SUBJECT :
FUEL LEAKING FROM THE FUEL SUB
TANK

Bulletin No :
 CM-22-064-02-KEEN
 Date : Jan. 08, 2024
 Ref.PB No :

MODEL : KX060-5, U56-5, AND U50-5

Change to Mandatory Campaign. Added affected serial number list.

12. Attach the mounting parts to the new fuel sub tank

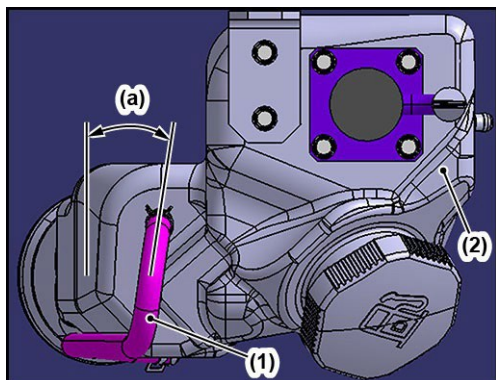
1. Attach the stay (1), the filter (2), the cap (3) and the fuel sensor (4) to the new fuel sub tank (5) in the reverse order from step 11.1 to 11.3.

- (1) Stay: Reuse parts
- (2) Filter: Reuse parts
- (3) Cap: Reuse parts
- (4) Fuel sensor: Reuse parts
- (5) Fuel sub tank (RD379-51615)

10. Attach the mounting parts to the new fuel sub tank

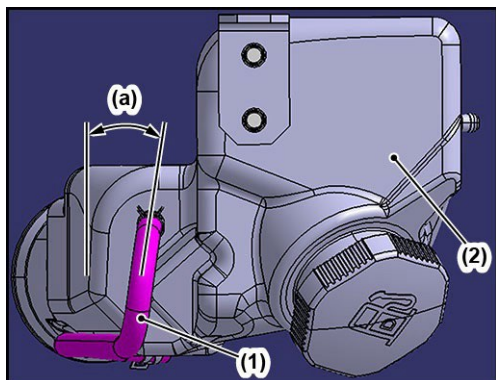
1. Install the stays (1), the filter (2), and the cap (3) to the new fuel sub tank (4) in the reverse order from steps 9.1 and 9.2.

- (1) Stay: Reuse parts
(2) Filter: Reuse parts
(3) Cap: Reuse parts
(4) Fuel sub tank (RD579-51615)
